Assessment of Dam Safety Coal Combustion Surface Impoundments (Task 3) Draft Report

Duke Energy Corporation

Miami Fort
Generating Station

December 4, 2009

Drawing Copyright © 2009 III Winners Circle, PO Box 5289 - Albany, NY 12205-0289 Main: (518) 453-4500 • www.ciacompanies.com	ASH POND A TYPICAL SECTIONS AND DETAILS	PROJECT NO. 20085.1050
	MIAMI FORT GENERATING STATION DUKE ENERGY CORPORATION NORTH BEND, OHIO	DATE: 11/2009 FIGURE 3

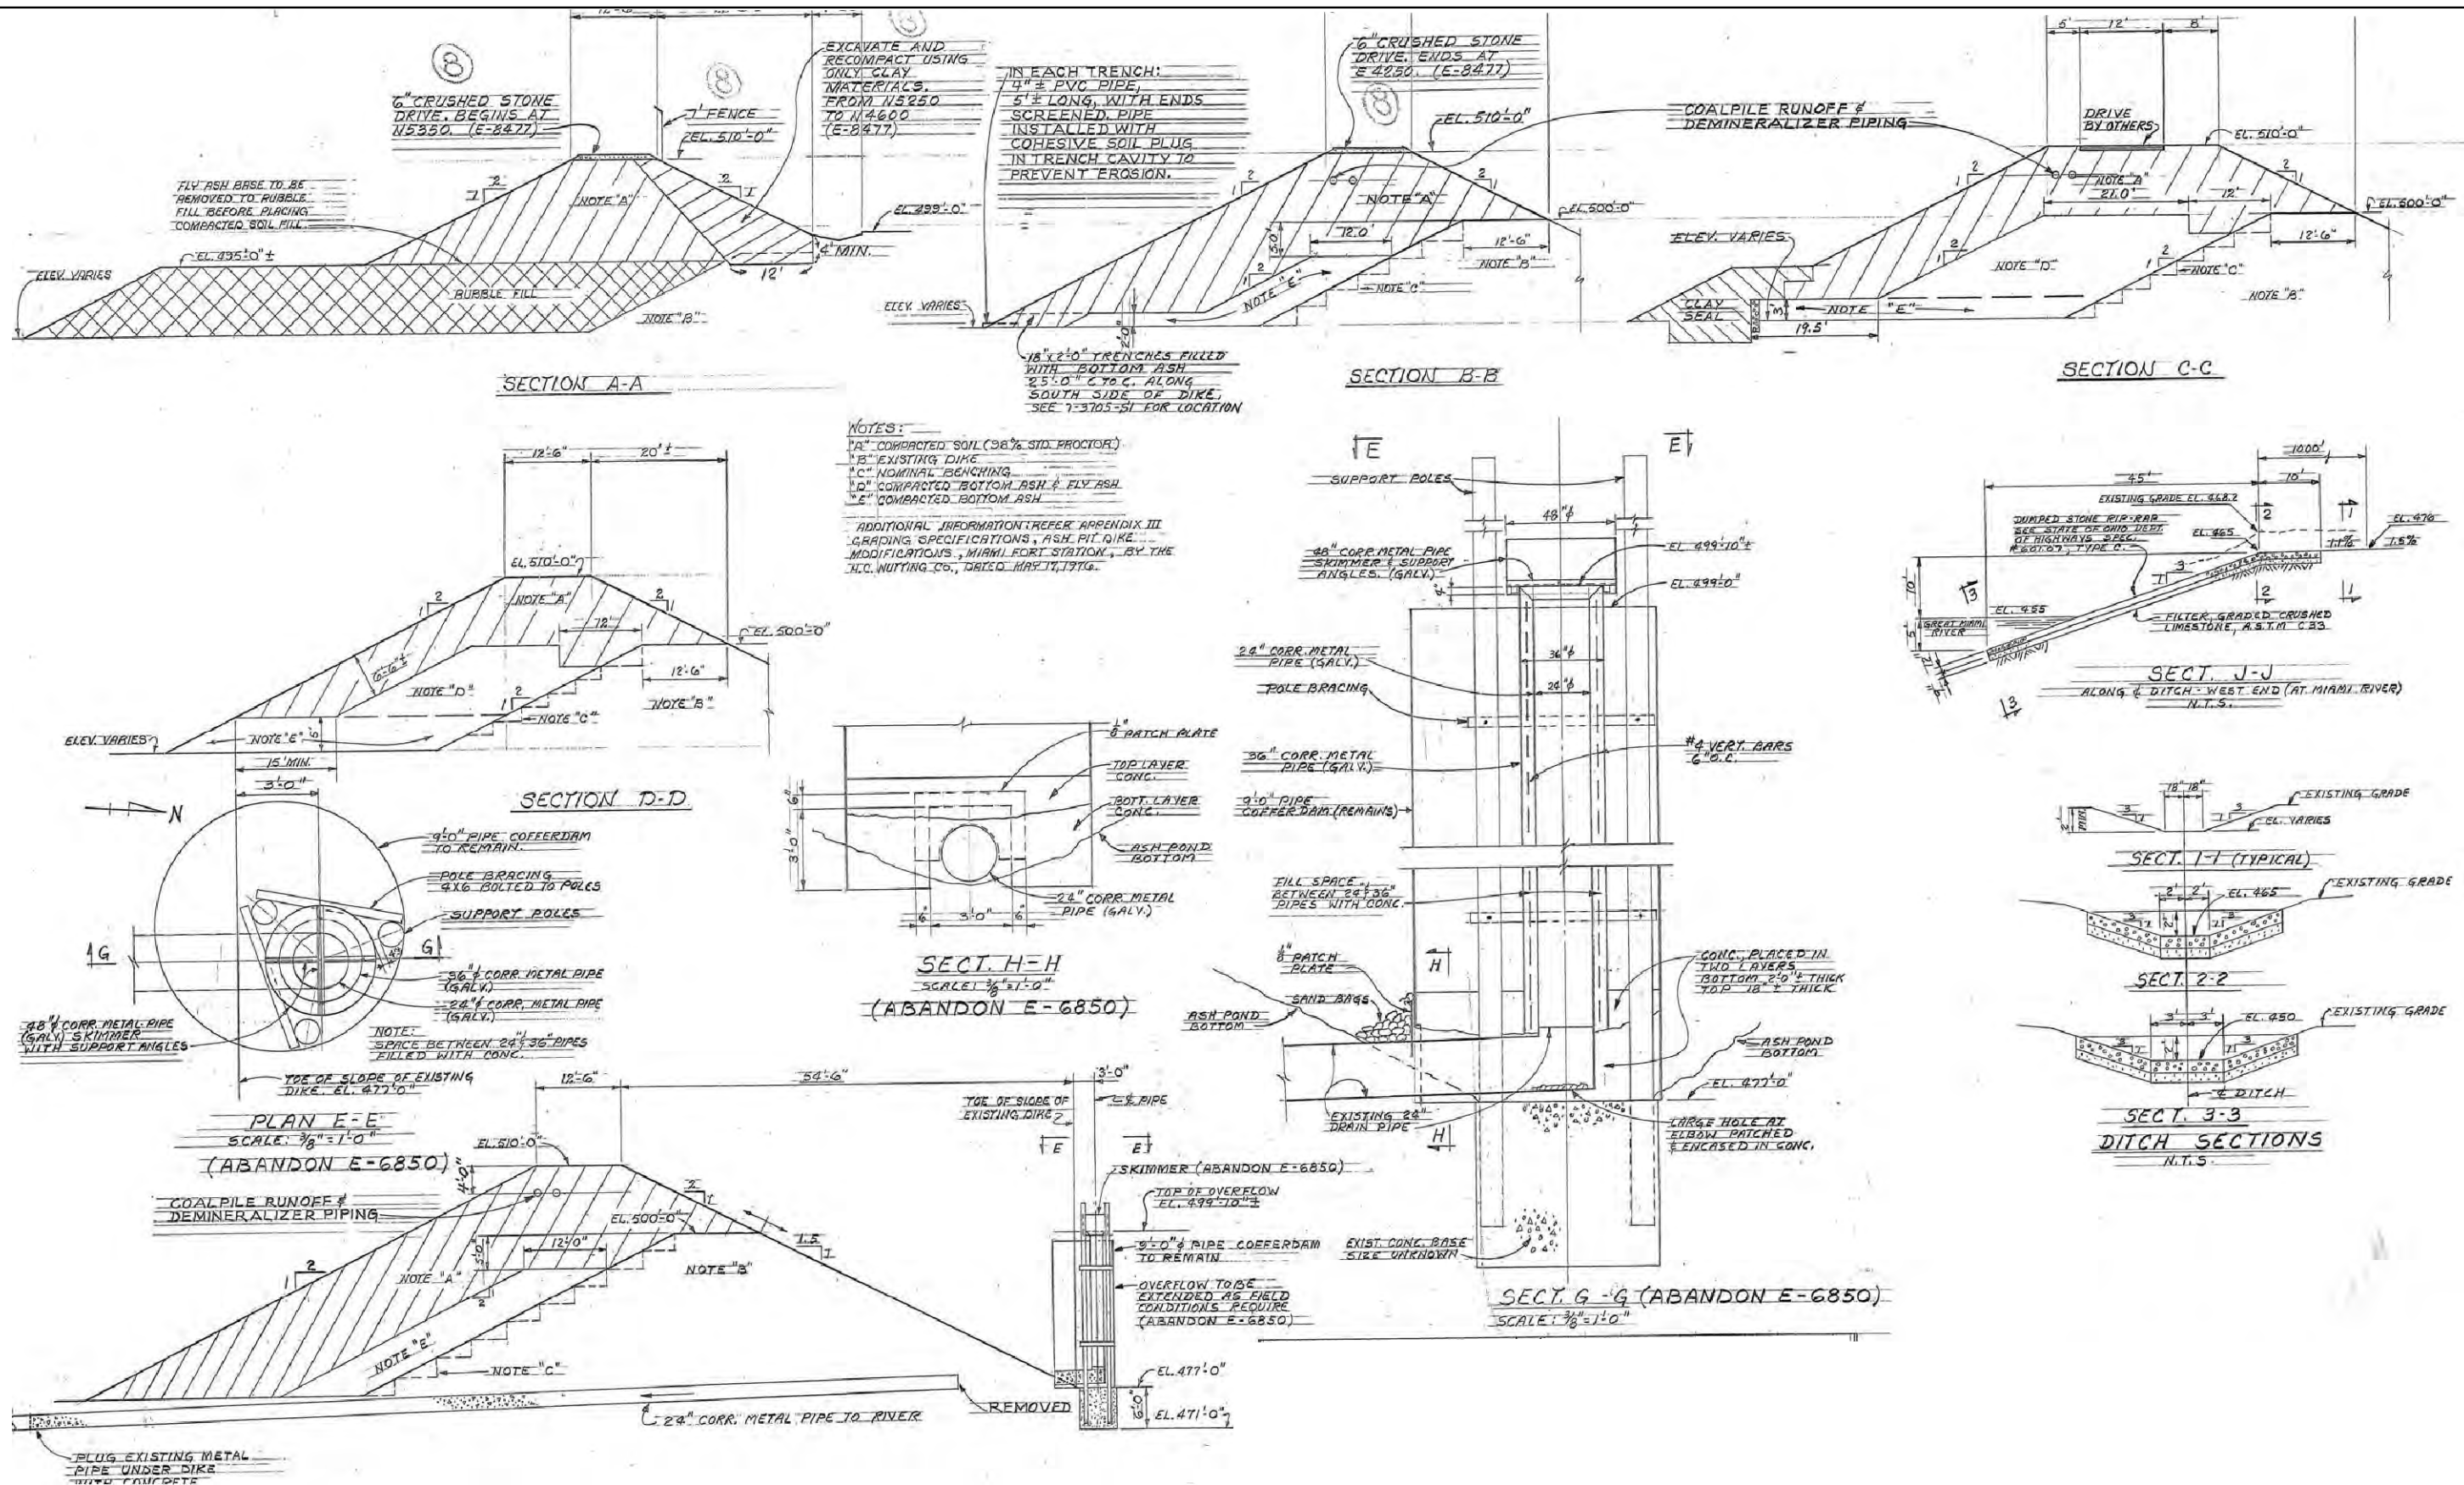
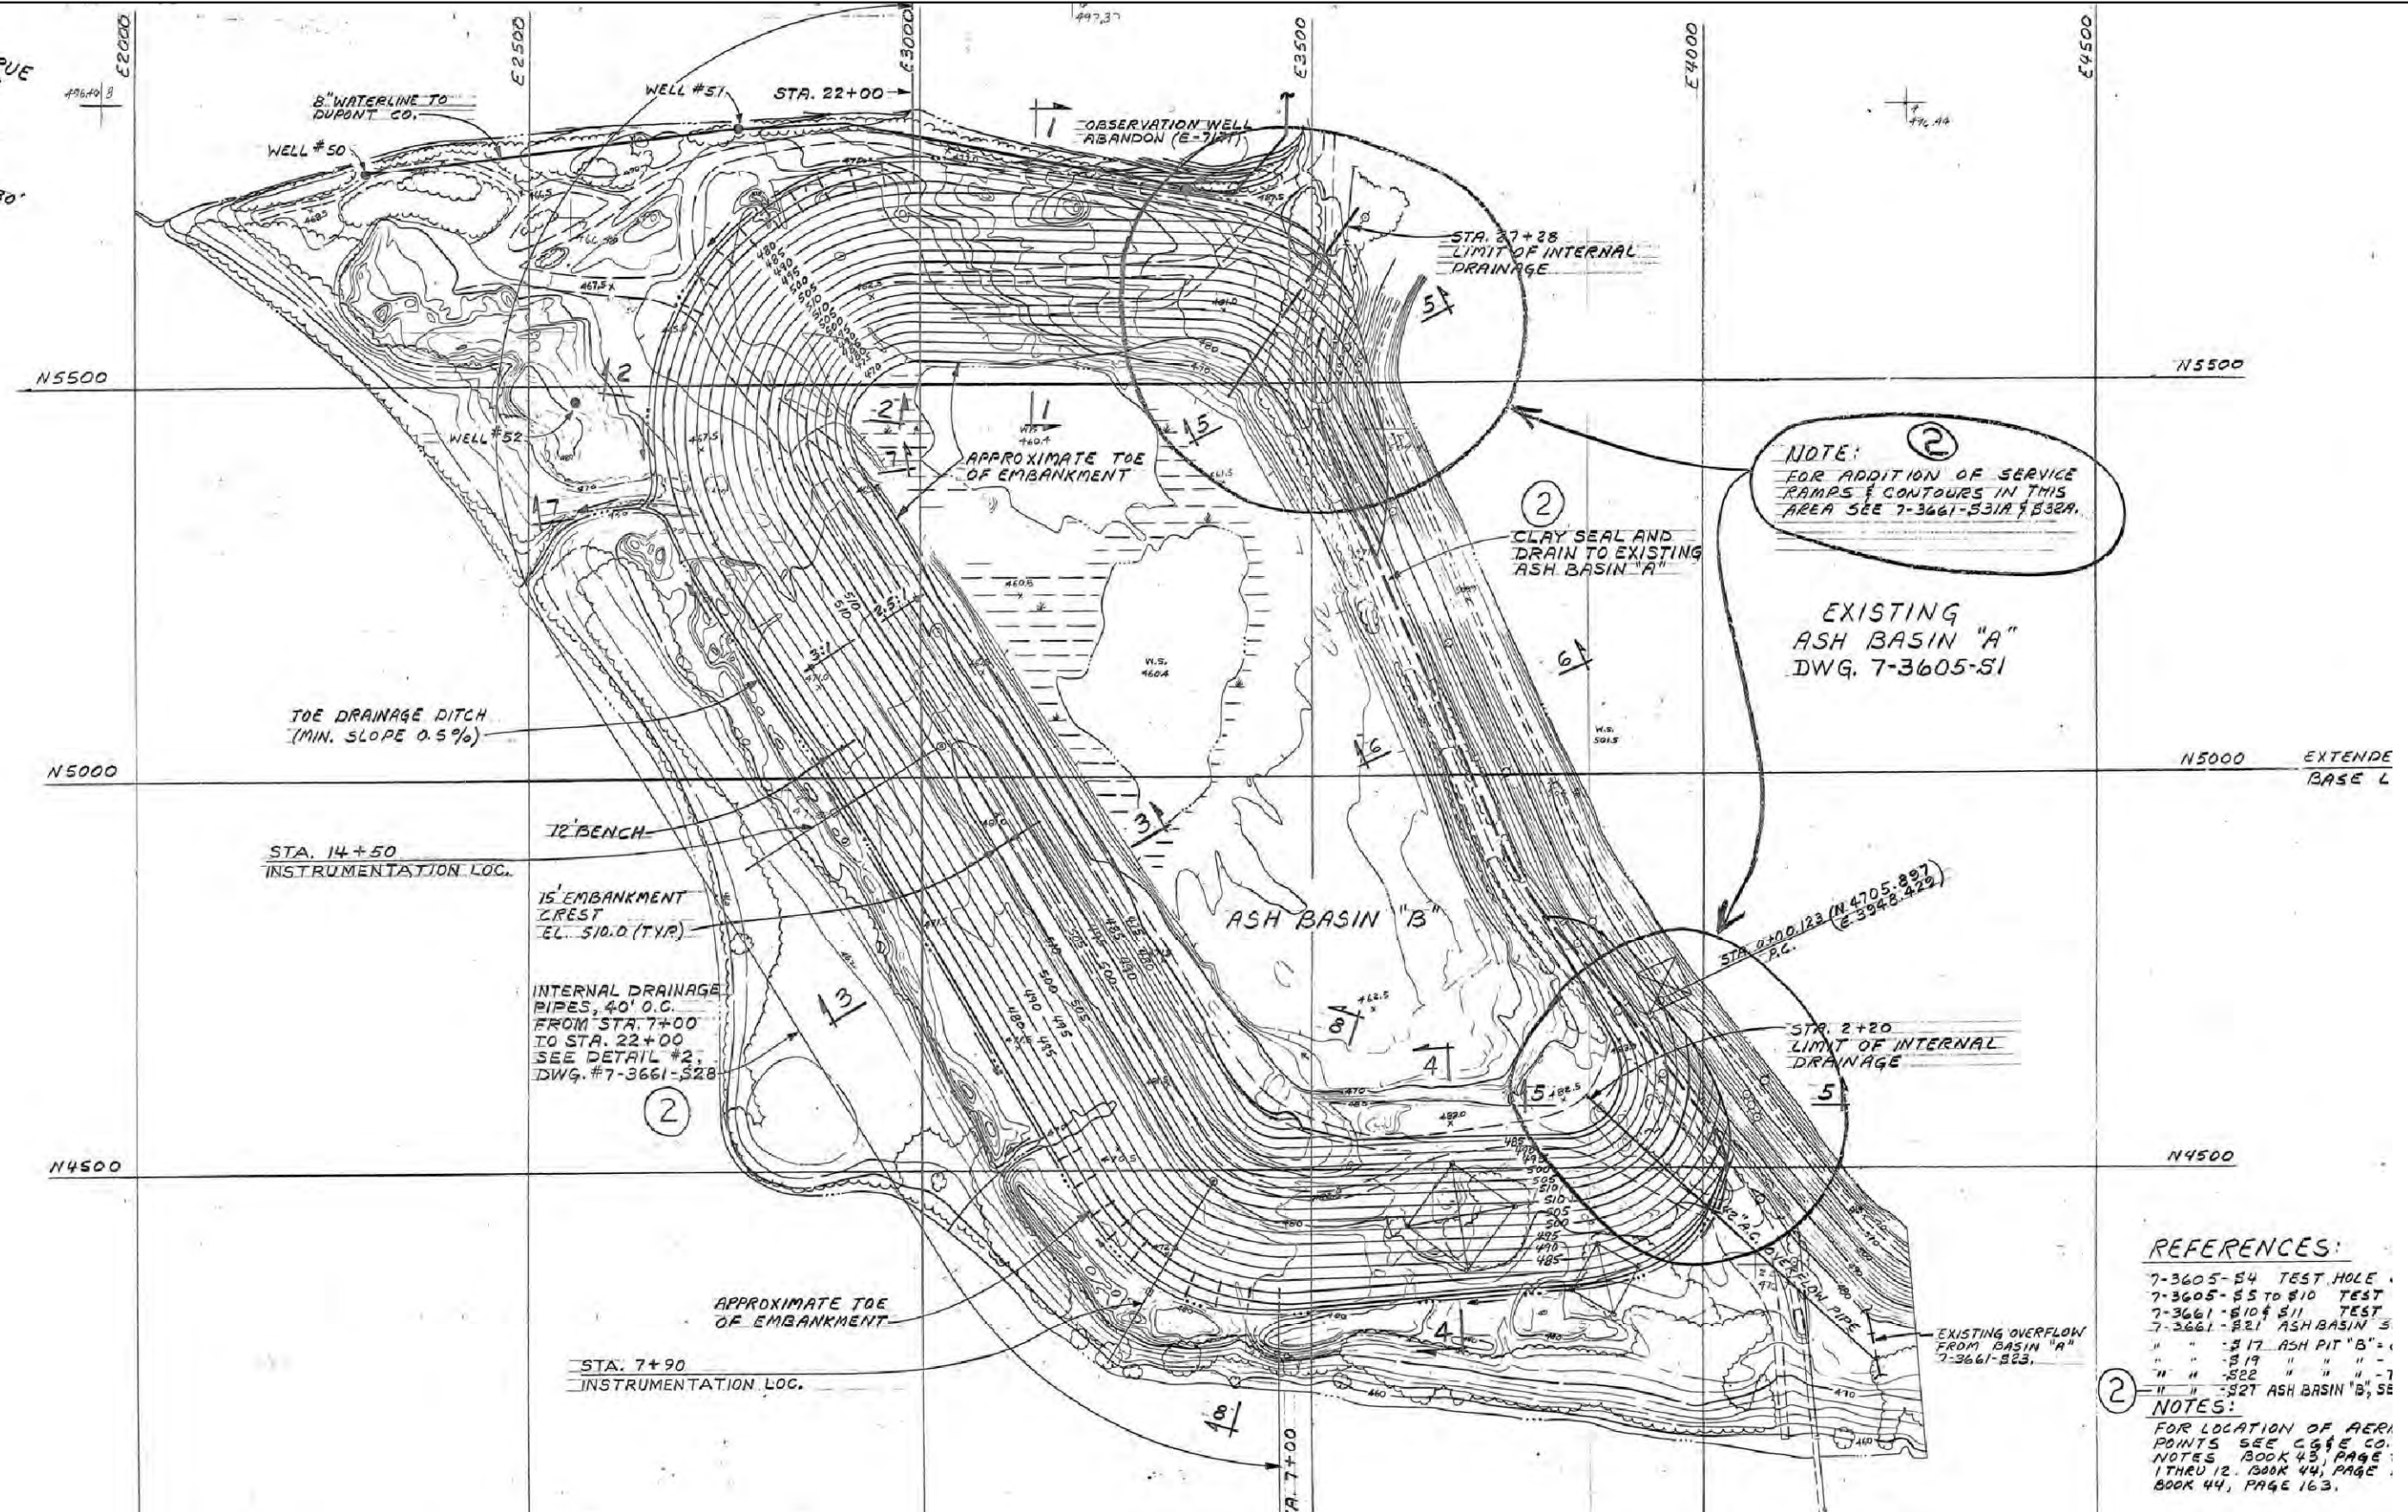
Design plans as shown on Figure 3 indicate that Ash Pond A was increased in height by ten feet in 1976 to Elev. 510 feet. Along the east side, the existing dike was only at Elev. 496 feet +/- and a slightly larger increase of up to 14 feet was required. In general the increase in the height of the dikes required the construction to be completed on the downstream side of the current berms. Construction materials to raise the dike to Elev. 510 feet consisted of a combination of compacted bottom and fly ash excavated from within the existing basin and soil borrow as show on Figure 3. The material was placed in discrete zones with the bottom ash used as a drainage media. Along the south side of Ash Pond A only on-site cohesive soils excavated from the future Ash Pond B footprint were used to increase the height of the dike. The 1976 report recommended this material transition due to the proximity to the Ohio River as well as a concern regarding weaker foundation soils as further discussed in Section 3.4.

Toe drains were placed within the drainage layer along the southern berm adjacent to the river as shown in Section B on Figure 3 and in plan view on Figure 2. Side slopes are currently 2 horizontal to 1 vertical on the inside of the basin and typically 2 horizontal to 1 vertical on the outside of the basin, with a steeper section of 1.5 horizontal to 1 vertical at the interior side slope near the discharge structure.
